**INTERIM CALCULATION  
CHANGE NOTICE (ICCN)/  
CALCULATION CHANGE  
NOTICE (CCN)**

C-259-1.01.11

Evaluation of Spent Fuel Pool for Westinghouse High Density  
Racks

This CCN re-examines the spent fuel pool gate drop on the Westinghouse high density spent fuel racks. Sheets 6A, and 292B to 292N are added. Sheets 6 and 292A are also revised. This calculation change minimizes conservatisms used in the previous Westinghouse analysis. Buoyancy, rack and gate geometry are used to determine the depth of penetration in the rack. The effects of rigging and the load blocks of the cranes are also considered.

Sheet No. 292 B

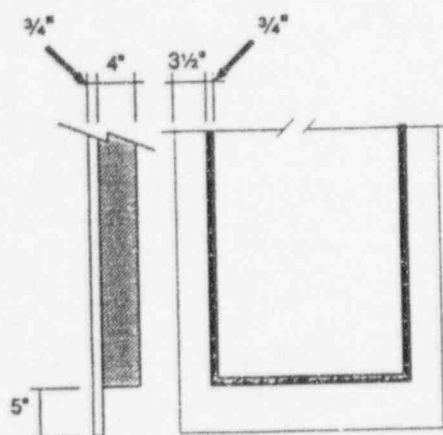
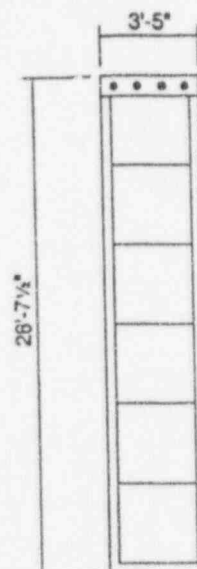
The drop of the gate was previously evaluated in Section 3.2.4.4 of Reference 18. This analysis supersedes the Westinghouse evaluation. There are two types of racks, Region I and II. The gate drop on a Region II rack will govern since there is a single cell wall between each assembly rather than 2 cell walls in a Region I.

The Westinghouse analysis considered the shape of the gate to be a 3/4" thick plate, 41 inches wide. The actual gate has a 3/4 by 4 inch stiffener plate perpendicular to the 3/4 inch plate at 5 inches from the bottom of the gate extending up the sides at 3 1/2 inches from each edge. The stiffener plate will also transfer energy into the rack and reduce the penetration depth.

Sheet No. 292C

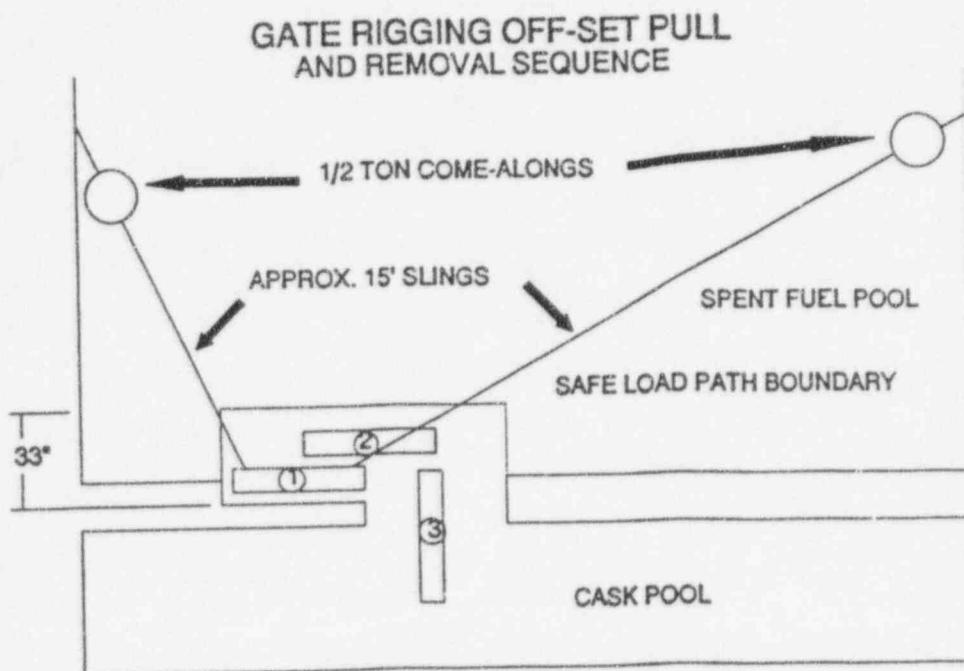
There is a gate at each end of the pool to consider. The transfer pool gate is handled by the new fuel crane without any special provisions. The cask pool gate is handled using the cask crane and requires special rigging. The cask crane will not travel far enough to allow centering of either hook over the gate. An offset pull is required using slings and come-alongs attached to the Spent Fuel Handling Machine (SFHM) rails or the SFHM bridge.

The come-alongs are supported by either the SFHM or rails with long slings to the gate. The come-alongs do not support any vertical weight of the gate. The come-along weight would not be seen by the gate during an impact due to the sling lengths being much longer than the drop height and each weighing less than 50 pounds.

Sheet No. 292 E

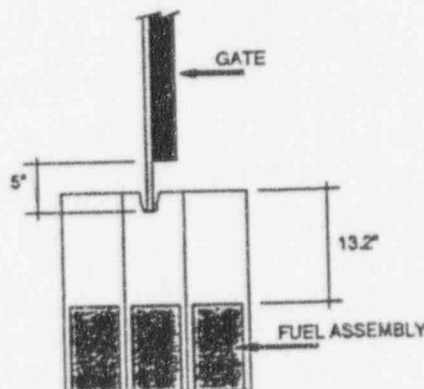
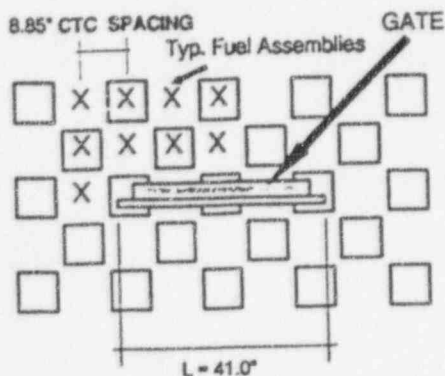
If the gate were to drop while halfway between the pools, it will land on the floor of the opening which is above the rack. This scenario is bounded by the gate drop analysis for the pool liner plate.

The worst case drop configuration results in the gate striking the middle of 4 cell walls. All other potential drop scenarios strike more cell wall length such that there is a greater resisting force.

After the gate penetrates 5 inches, the side stiffener plate will strike the rack. Since the gate bottom is only 3/4" thick, the initial failure mode expected is a local "knife edge" cut into the cell wall as shown.

Sheet No. 292 F

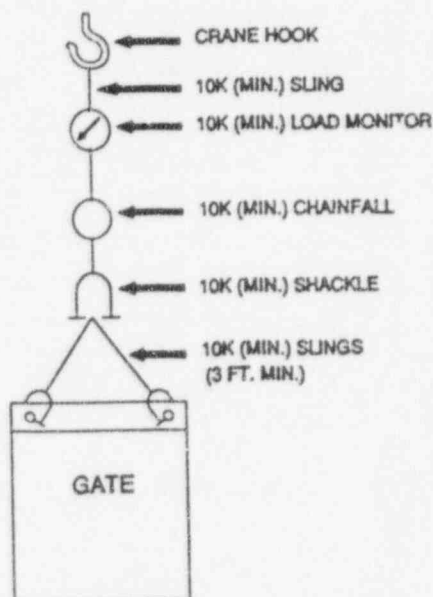
The drop weight of the gate shall include the rigging and load block as required by NUREG-0612. Use the cask crane auxiliary hoist hook weight. Rigging weights are based on published manufacturer data for typical components for the configuration shown in the gate removal procedure:

Weights
10T Hook & Block =	265 lbs
Load Cell =	50 lbs.
3 Slings =	30 lbs.
Chainfall =	100 lbs.
3 Shackles =	20 lbs.
	-----
Total =	465 lbs.

Sheet No. 212 I

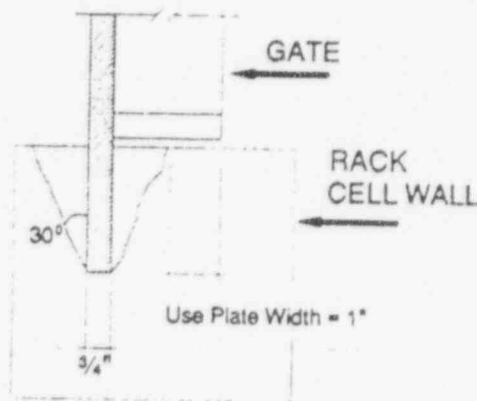
The 3/4 inch plate has already penetrated the rack and continues to penetrate 5 inches below the 4" reinforcing plate. When the 4" wide reinforcing plate hits the top of the cell, the wall will already be damaged from the initial impact from the vertical plate. The damaged area will make approximately a 20 to 30 degree angle with the bottom of the vertical plate as it penetrates the wall. As such, only a fraction of the wall remains available for further energy absorption. Take an angle of 30° from the bottom of the vertical angle.

The load,  $P_2$  per inch depth, for 3/4 inch plate plus 1" of reinforcing plate: where  $w = 1.75$  in.

Sheet No 292 J

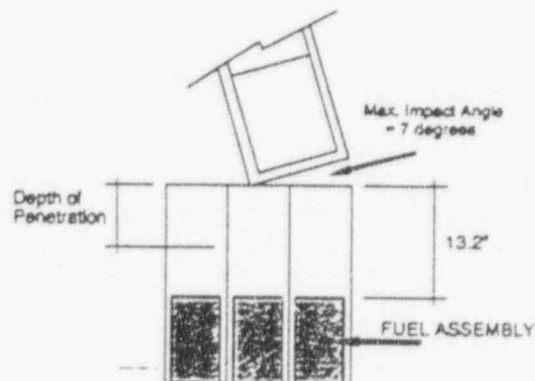
The 3/4" plate alone will hit for the first 5 inches of penetration. Then the reinforcing plate hits to a depth of (d - 5) inches. The impact energy must equal the resisting energy. The depth of penetration is also included as part of the impact energy to account for the additional energy to its final resting depth. This is conservative since the velocity is decreasing once the gate hits the rack.

$$4295 \text{ lbs} \times (30 + d) \text{ in} = 4 \times [4067 \text{ lbs} \times 5 \text{ in} + 9489 \text{ lbs} \times (d - 5) \text{ in}]$$

$$d = 7.0 \text{ in.} < 13.2 \text{ in.}$$

In this case, the gate could potentially damage 5 rack cells. None of the fuel assemblies would be directly hit by the gate.
